Amendment Notice 1

| Licence Number | L8578/2011/1 |
| Premises | Garden Well Gold Project M38/343, M38/250, M38/237, M38/352, M38/1249, M38/1250, M38/1257, M38/283, M38/1251, M38/292, M38/630, M38/114, M38/341, L38/201, L38/202, L38/203, L38/204, L38/212, and L38/219 BANDYA WA 6440 |

| Instrument | Issued | Amendment |
|--------------|------------------|--|
| L8575/2011/1 | 19 December 2016 | Amendment Notice 1 Licence amendment to include conditions relating to the construction of TSF2 |

Map of monitoring locations to be added to Schedule 1

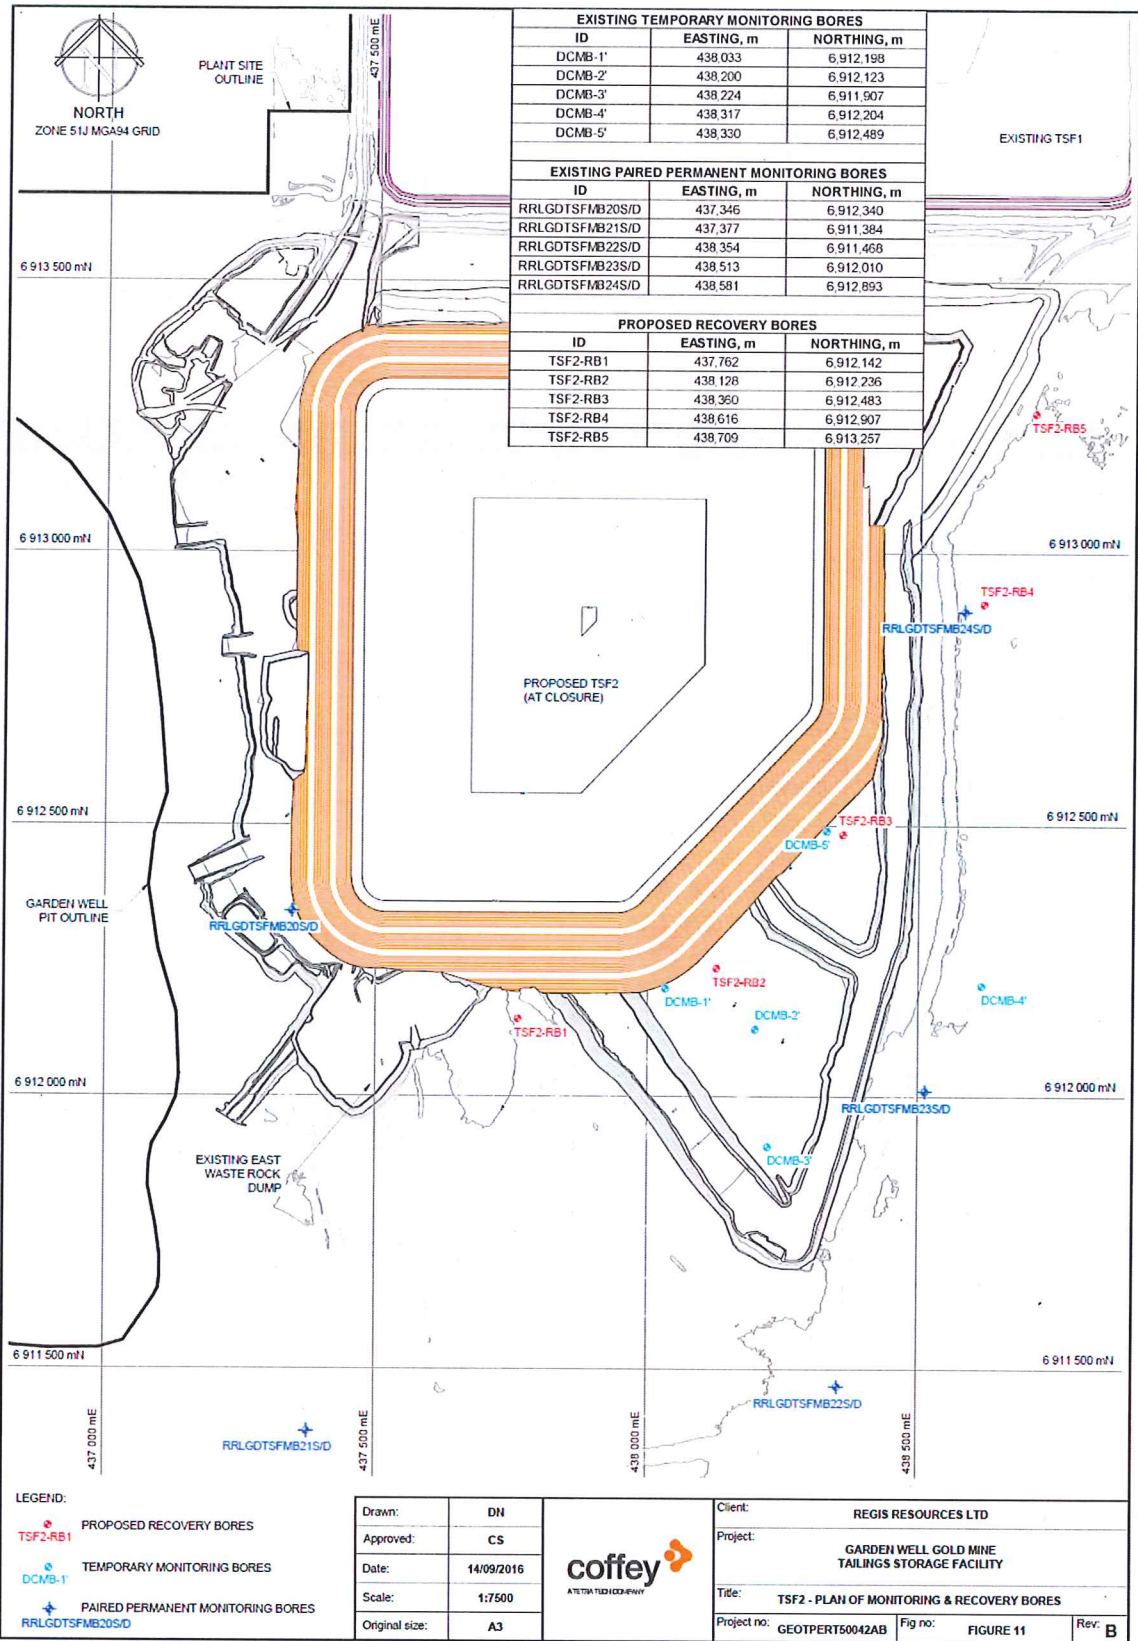
9 Condition 3.3.1 of the Licence is amended by the insertion of the red text show in underline below:

| <u>Tailings deposition</u> | <u>Volumes of tailings deposited into the TSF</u> | <u>KL</u> | <u>=</u> | <u>Continuous</u> | <u>None specified</u> |
| | <u>Volumes of water recovered from the TSF</u> | | | | |
| | <u>Volumes of seepage recovered and reused to Process Plant</u> | | | | |

10 The Licensee shall undertake the monitoring in Table 3.4.1 according to the specifications in that table and record and investigate results that do not meet any limit specified.
